Ref. No. 201406073  
Petition No. 2981

Request to Encroach into the East-West Public Alley 20 ft. wd. in the block bounded by Clifford, Park, Washington Blvd., and Woodward.

## REVISED ENCROACHMENT LOCATIONS

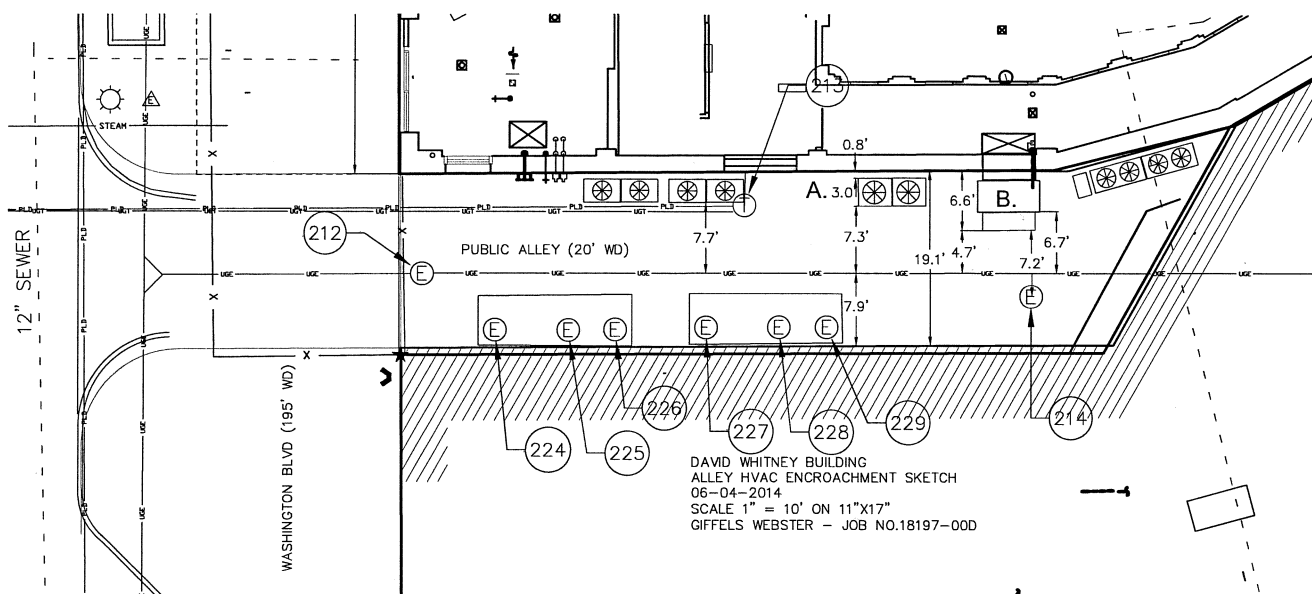
- ( ) Involved; but asking you to hold action on this petition until further notice.
- ( ) Involved; but no objections to the property change – provided an easement of the full width of the public right-of-way (street, alley or other public place) is reserved.
- ( ) Involved; the nature of our services, and the estimated costs of removing and/or rerouting such services are:
- (x) Involved; have no objection to the request to encroach into the east-west public alley 20 ft wide in the block bounded by Clifford, Park, Washington Blvd., and Woodward as shown on drawing X 2981 marked “Revised Encroach”, dated 06/14, provided that a minimum clear width of 12’4” as shown on the proposed layout is maintained for vehicular access to utility vehicles.
